DEPARTMENT OF ENVIRONMENTAL MANAGEMENT  
OFFICE OF WATER RESOURCES  
FRESHWATER WETLANDS PROGRAM  
APPROVED WITH CONDITIONS  
AS SPECIFIED IN THE LETTER OF APPROVAL  
DATED OCT 29 2008 FILE # 08-0201  
NO CHANGES ALLOWED WITHOUT PRIOR APPROVAL  
APPROVAL PLANS MUST BE AT COMPTON SITE

PROPOSED OWTS NEW CONSTRUCTION  
PREPARED FOR  
**SHEILA QUINTIN**  
ASSESSOR'S PLAT 40 LOT 70-2 (FORMERLY 69 & 70)  
COLEBROOK ROAD  
LITTLE COMPTON, RHODE ISLAND  
SCALE: 1" = 30' DATE: JUNE 3, 2008  
**Civil Engineering Concepts, Inc.**  
34A MAIN STREET P.O. BOX 5323  
LITTLE COMPTON, RI 02837 NEW BEDFORD, MA 02742  
PH: (401) 592-0177 FAX: (401) 592-0178 (508) 990-4900

SHEET 1 OF 2

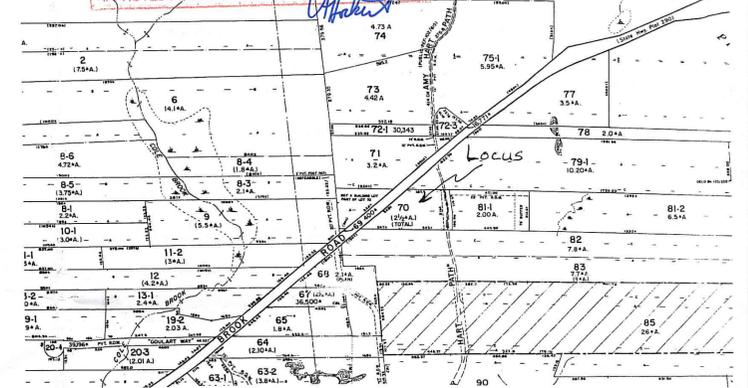
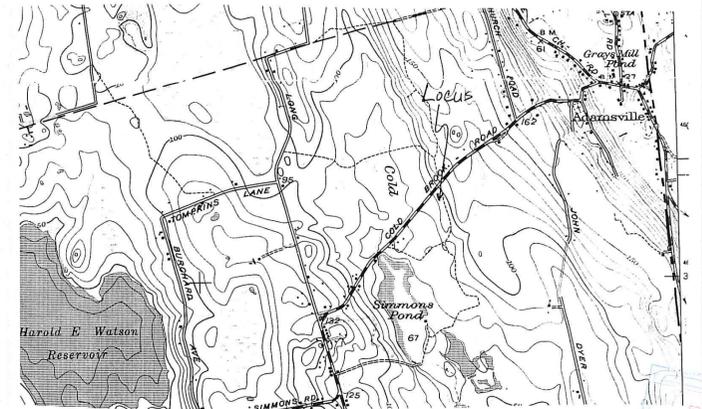
Permanent Markers  
Required along  
Limits of Disturbance  
per RI DEM, see  
condition No.11

Limits of Disturbance  
and Erosion Controls  
Revised per RI DEM
